**RE: Lot 13 Block 10 Volcano Cliffs Unit 22 SAD 228
6300 Petirrojo Rd. NW
Grading and Drainage Plan
Engineers Stamp Date 2/10/2020 (D10D003F13A)
Pad Certification Date 3/27/2020**

DRAINAGE AND TRANSPORTATION INFORMATION SHEET (REV 6/2018)

ENGINEER'S SEAL 2/10/20 DAVID SOULE P.E. #14522	6300 PETIRROJO	DRAWN BY WCWJ DATE 2-04-20 21721-LAYOUT-3-20-17
	GRADING AND DRAINAGE PLAN	SHEET #
	 1606 CENTRAL AVENUE SE SUITE 201 ALBUQUERQUE, NM 87106 (505) 872-5998	JOB # 21721

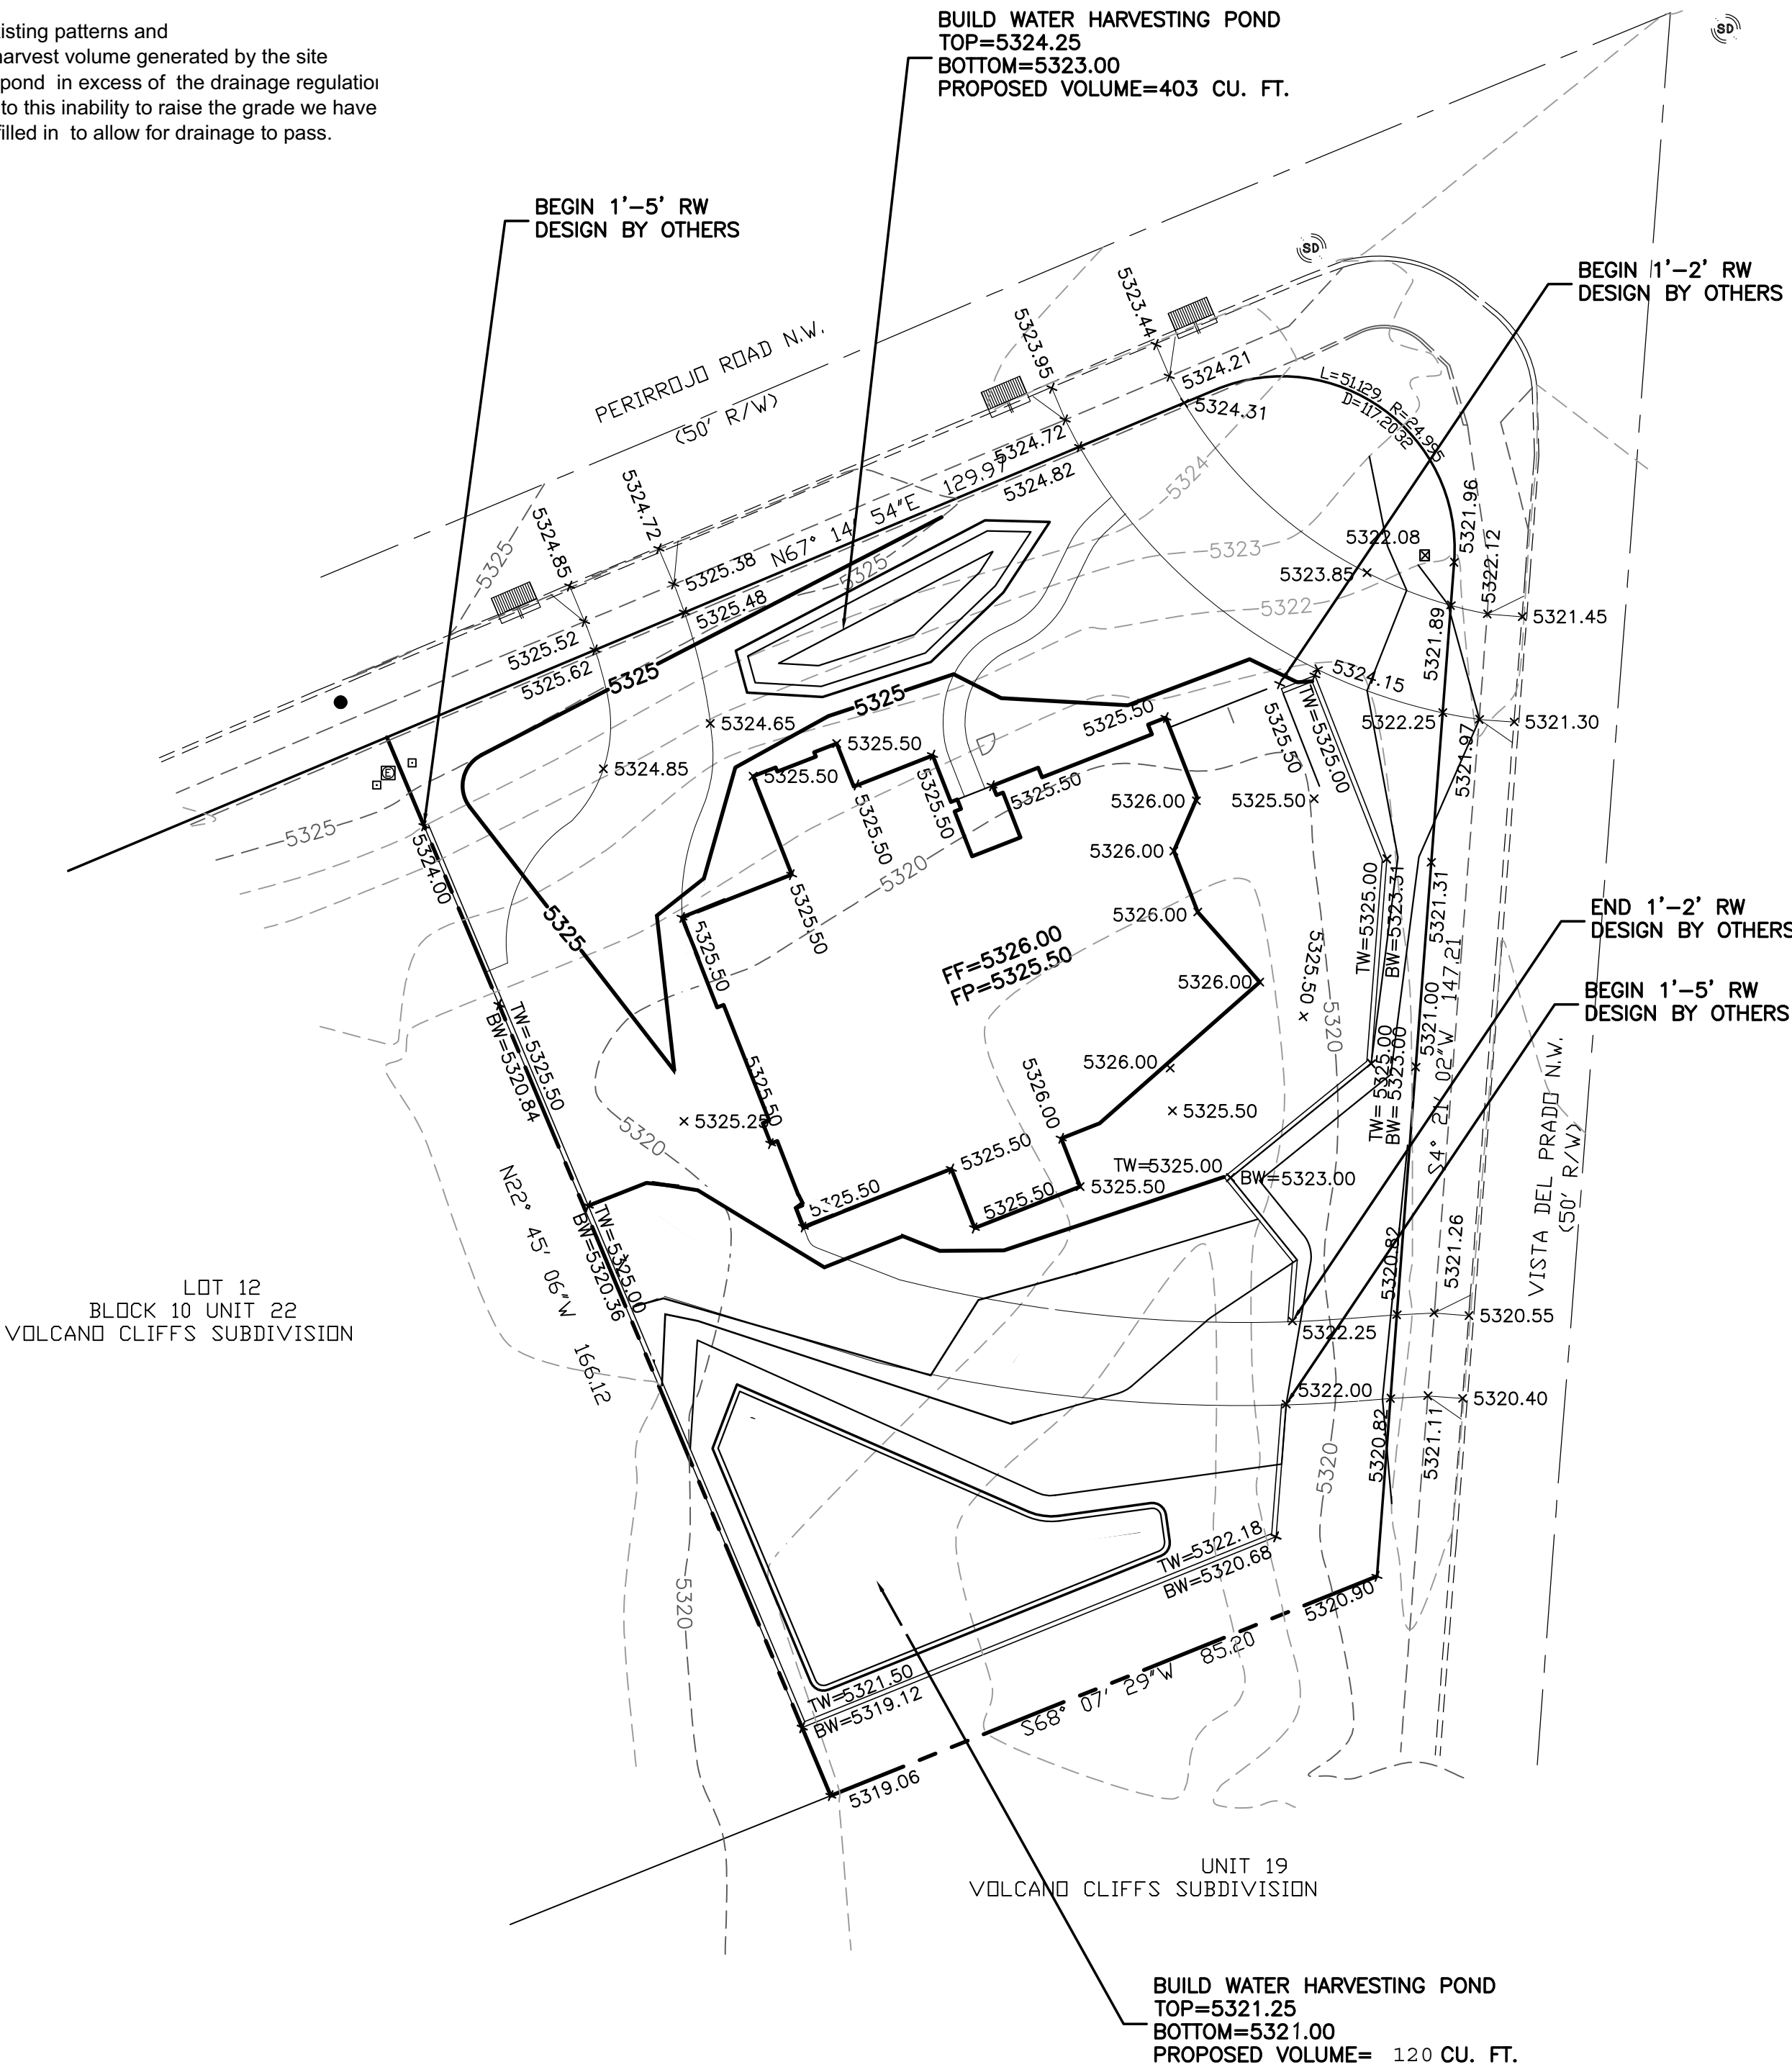
Based upon the information provided in your submittal received 5/1/2020, this plan is approved for Building Permit.

Reiterate to the Owner/Contractor that a separate permit for a garden/retaining wall must be obtained, with the approved G&D plan dated 2/10/2020 and Pad Certification Date 3/27/2020.

Prior to Certificate of Occupancy release, Engineer Certification per the DPM checklist of this plan will be required.
